TOWN OF VERNON
Planning & Zoning Commission (PZC)
Virtual Meeting Notice & Agenda
Thursday, February 4, 2021, 7:30 PM

SUBJECT: PZ 2021-01, 1129 Hartford Tpke.

An Application **[PZ-2021-01]** has been submitted by Chapman Acres, LLC, for a Site Plan of Development to replace an exiting 3,600 s.f. maintenance building with a 6,650 s.f. maintenance building, including demolition and associated site work at the Mt. Vernon Apartments, 1129 Hartford Tpke. (Assessor ID: Map 43, Block 68, Parcel 22A).

Maintenance Building
Mt. Vernon Apartments
Chapman Acres LLC
1120 Hartford Turnpike, Vernon, Connecticut
Assessor's ID# 43-0068-0022A Zone: PRD

Site Plan

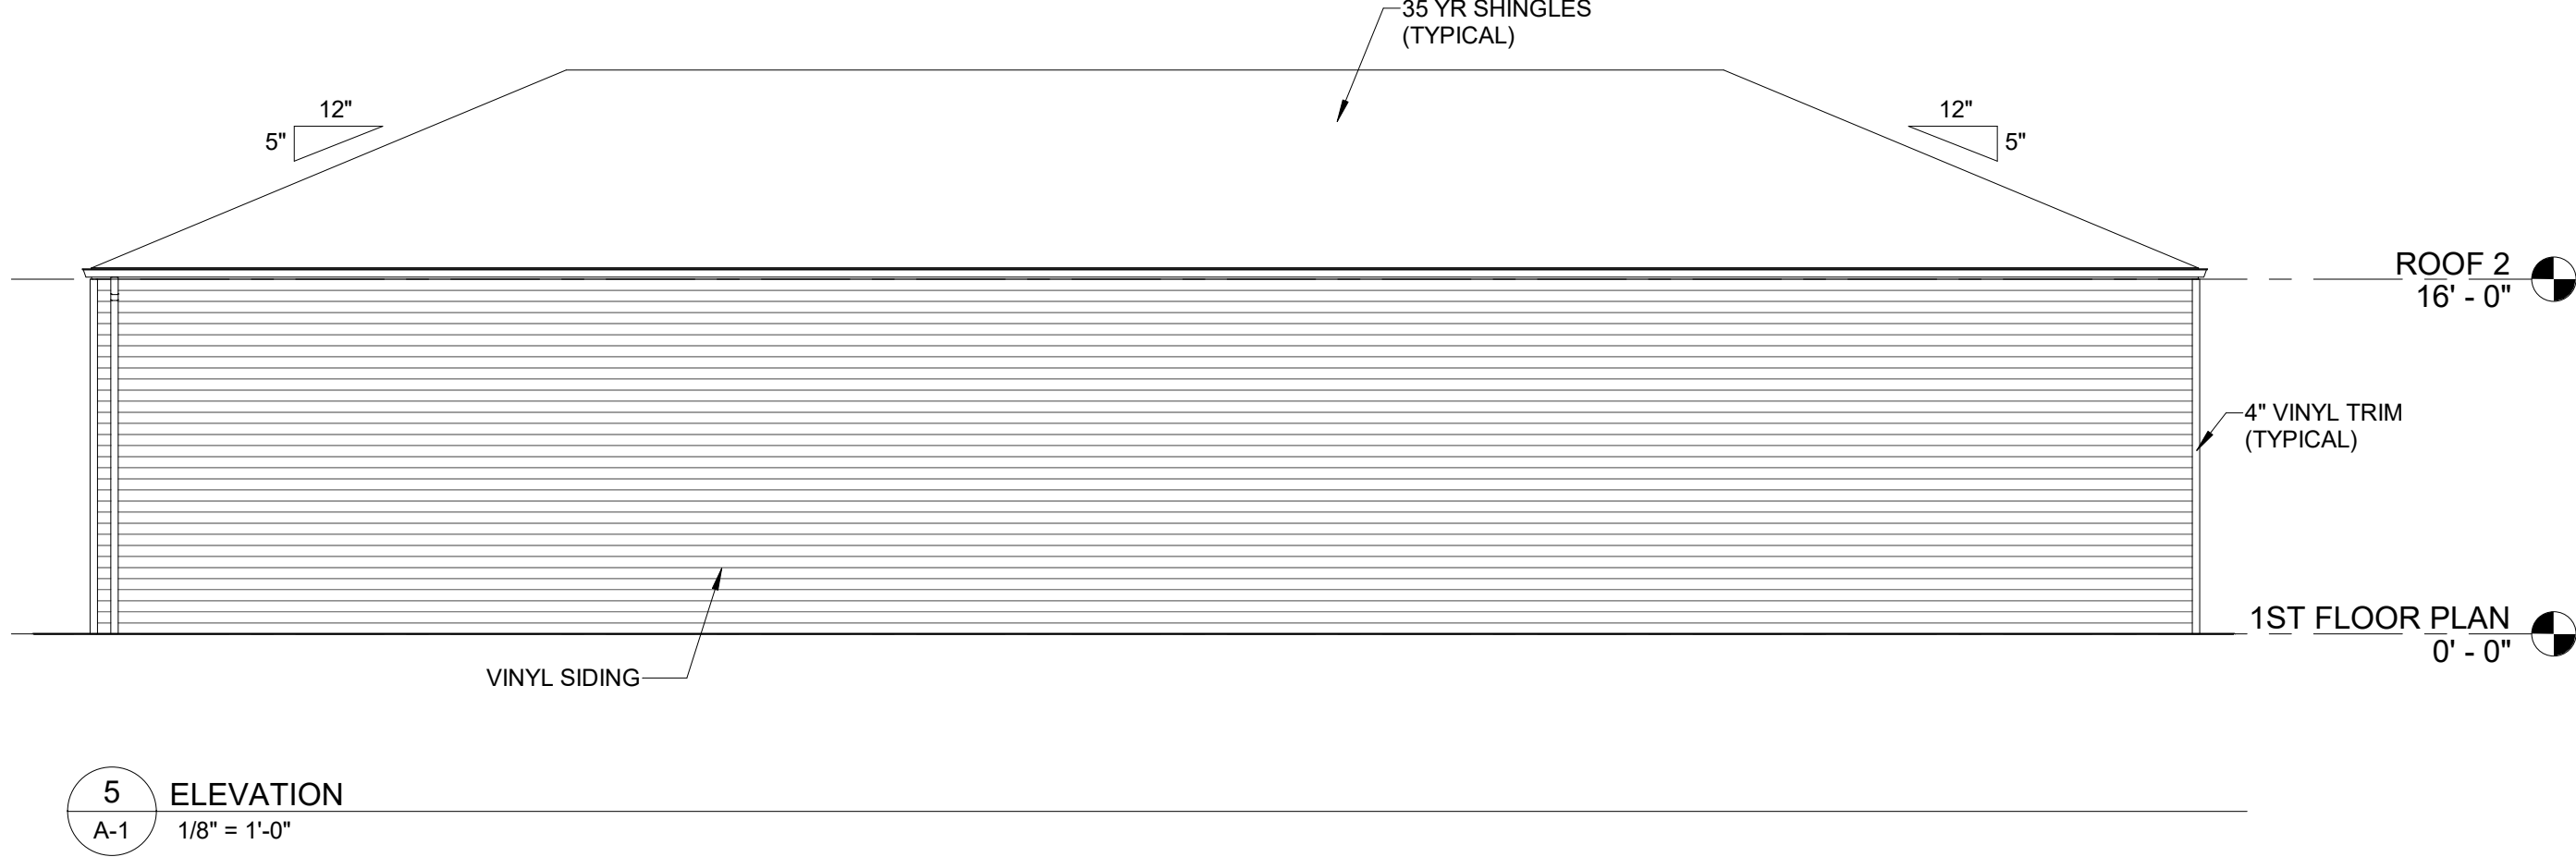
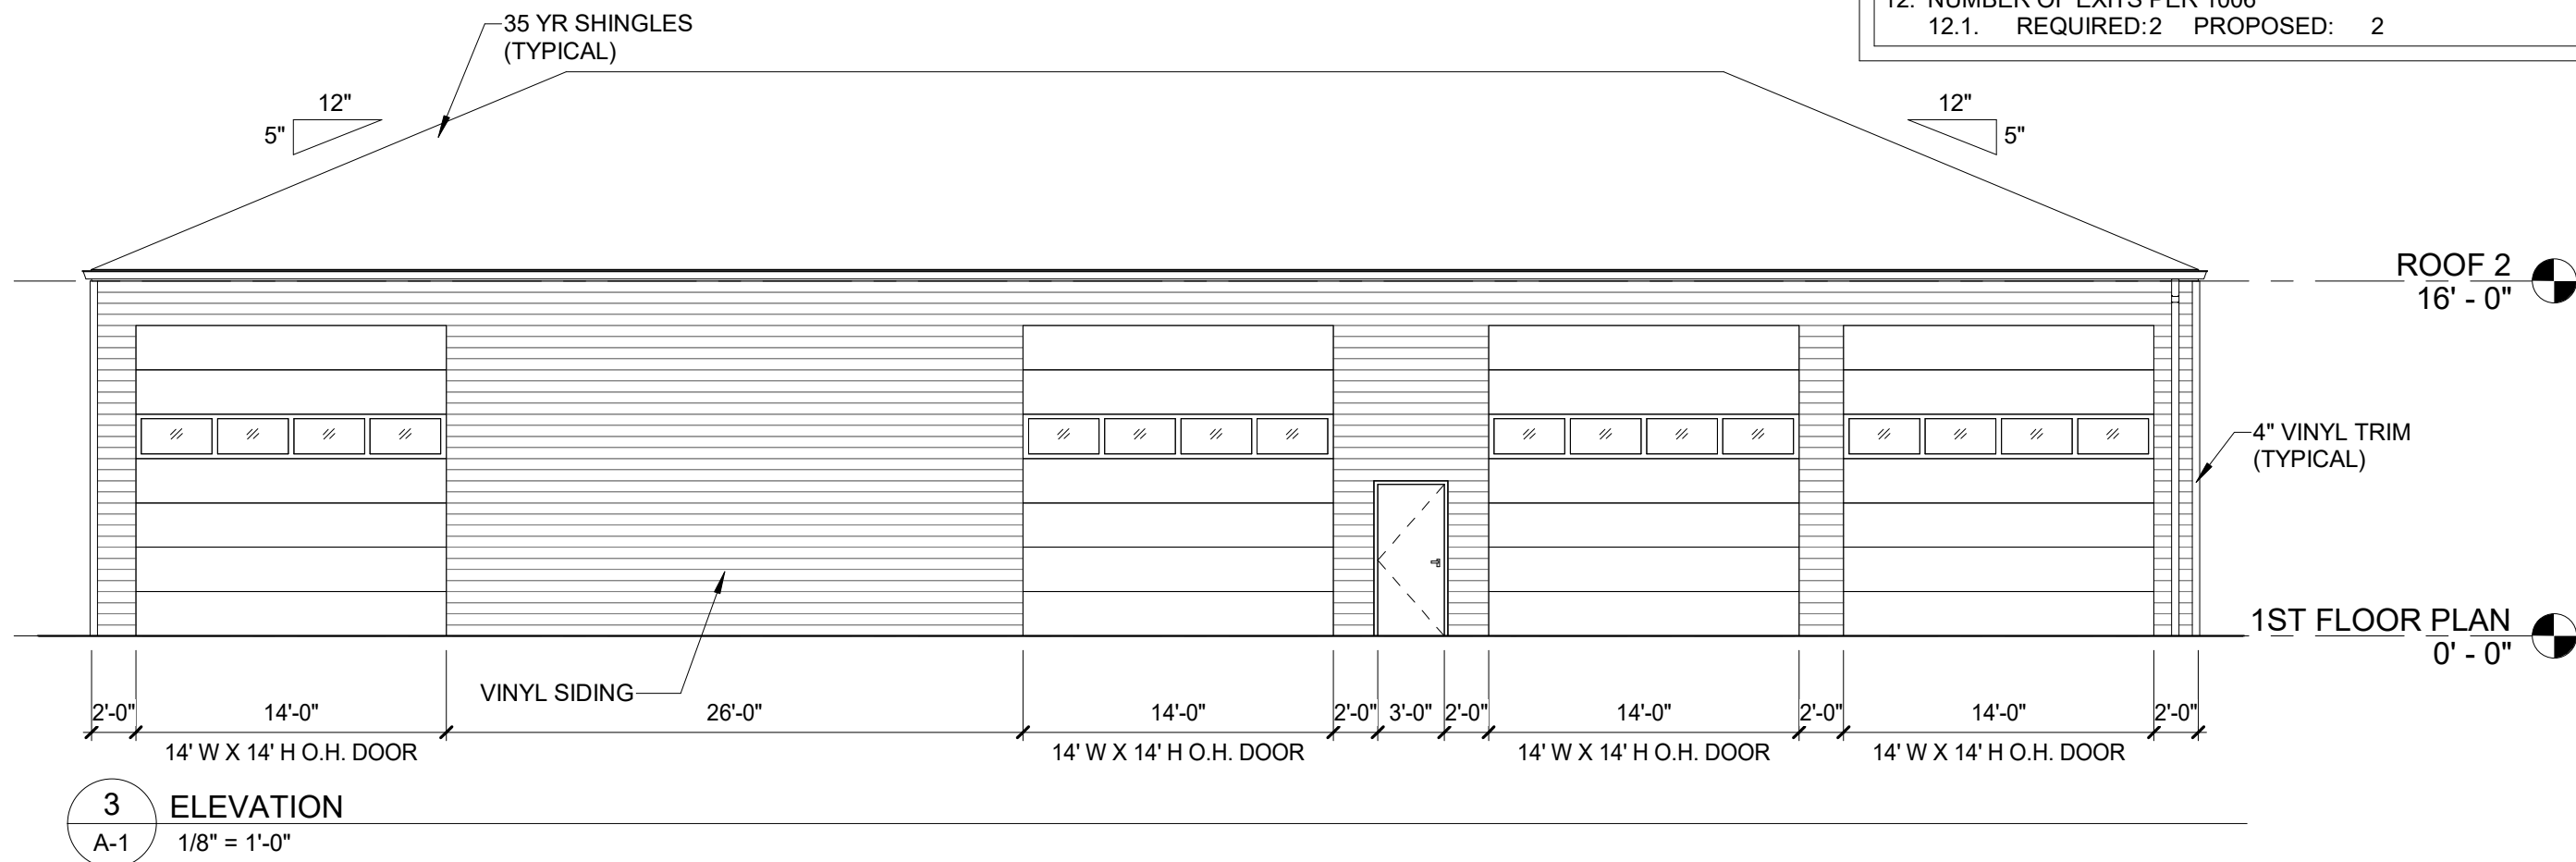
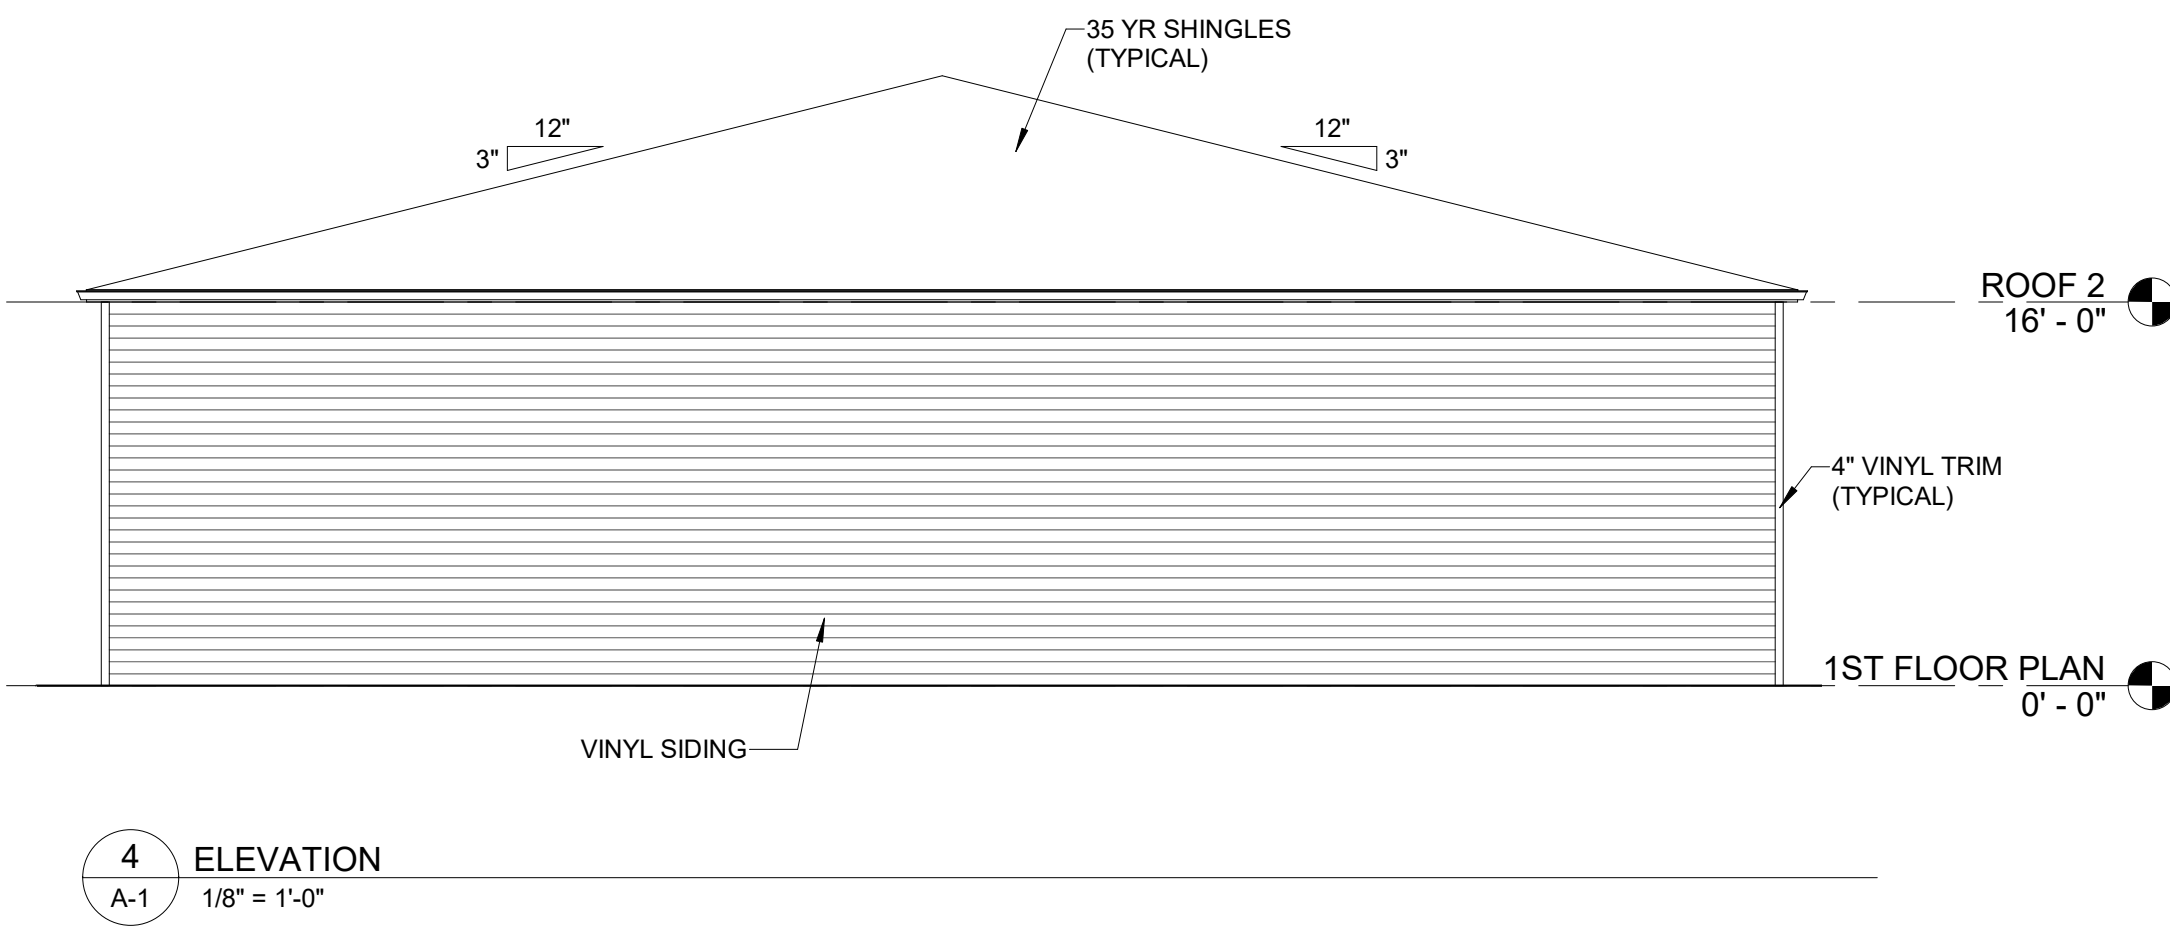
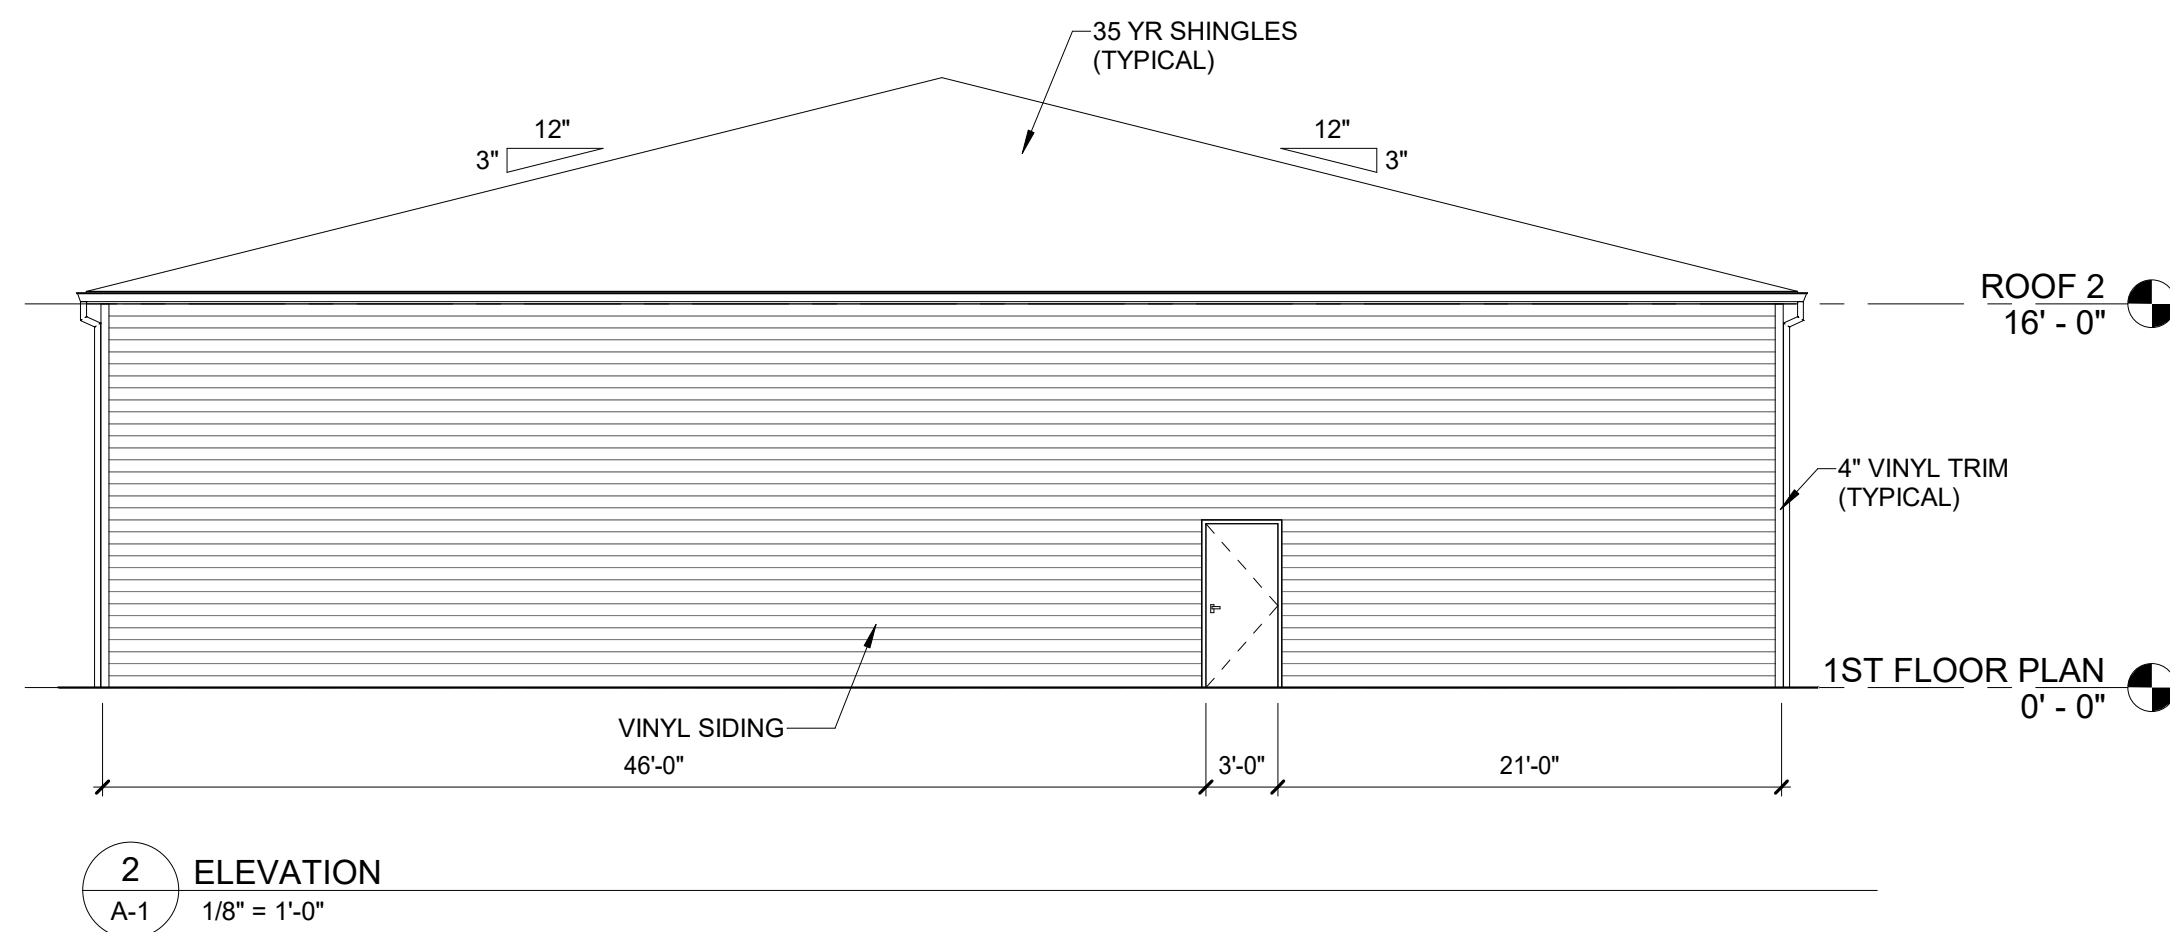
I have reviewed the site plan, LID Checklist and Drainage calculations and the project appears to meet our objective to not increase stormwater runoff resulting in off-site impacts. I believe that some type of siltation barrier along the north and east limit of disturbance and a recommended seeding schedule as part of the short term and long term stabilization program should be included on the plan.

My final, very minor comment – we should have some specification of the size of the trees proposed for the screen along the easterly line. Arborvitae grows pretty quickly, but this new building is considerably larger than the current one, so something in the 4 to 6' height range might appropriate and provide a function screen within a few years. 2 gallon container plants from the big box retailer will not be effective for many, many years. Just a suggestion.

I would ask you to consider placing all or at least portions as it is visible from the neighboring property

Is the perimeter fence owned by the Applicant?

Its in pretty bad condition; is there a plan to erect a new one (at least adjacent to the apartment complex to the east?)

I have revised the attached Site Plan to address the comments received thus far. Revisions include:

- Add a call-out to "repair the existing chain link fence east of the building as necessary"
- Note the size of the arborvitae to be 4'-6'. However, after further research and determining that these trees grow 3-5' per year and can have a 15'-20' spread, I increased the spacing from 6' to 8'.
- A silt sock sediment barrier has been added to the north and east of the area of disturbance, and a detail added to the plan.
- The call out for loam and seed has been revised to identify the seed as a turf mix and specify the dates for seeding.

The fence does belong to the applicant. However, there are not plans to replace it. We are proposing a line of arborvitae adjacent to the apartment complex along the fence which should break it up some.
